MSOX3024A-05A

Modification Recommended Internal Only Document Service Note

MSOX3024A – Oscilloscope, 200MHz, 4 Channels + 16 Digital Channels

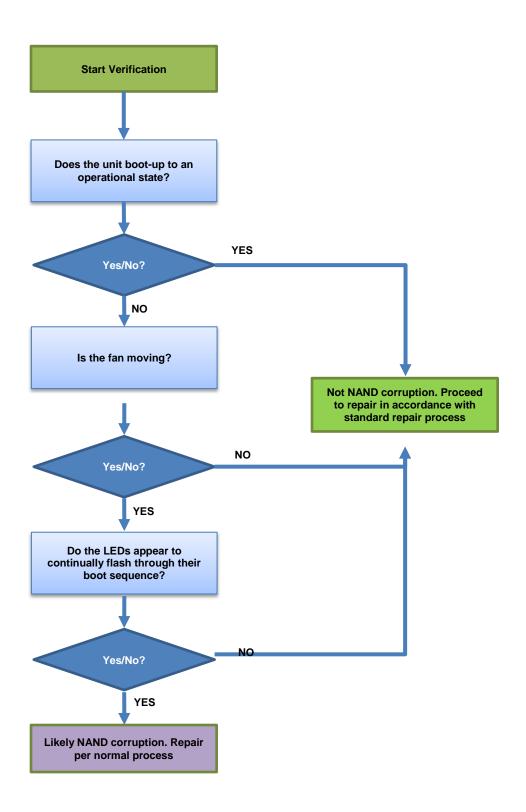
Since this is a known issue, service center personnel should not spend time troubleshooting non-booting scopes. If a customer reports that the scope is not booting and the LEDs are flashing, or that the scope continually reboots, please simply exchange the scope's core. If he customer does not fully describe a non-boot, please call the customer to verify the behaviors described in the diagram on Page 3.

- All scopes requiring repair due to NAND memory corruption are to be repaired with no parts or labor cost to the customer regardless of warranty status.
- All scopes requiring repair due to issues not related to the NAND memory will be repaired per normal process normal warranty conditions apply.
- Under no circumstances will the repair/exchange labor time for these scopes exceed 90 minutes, including calibration.
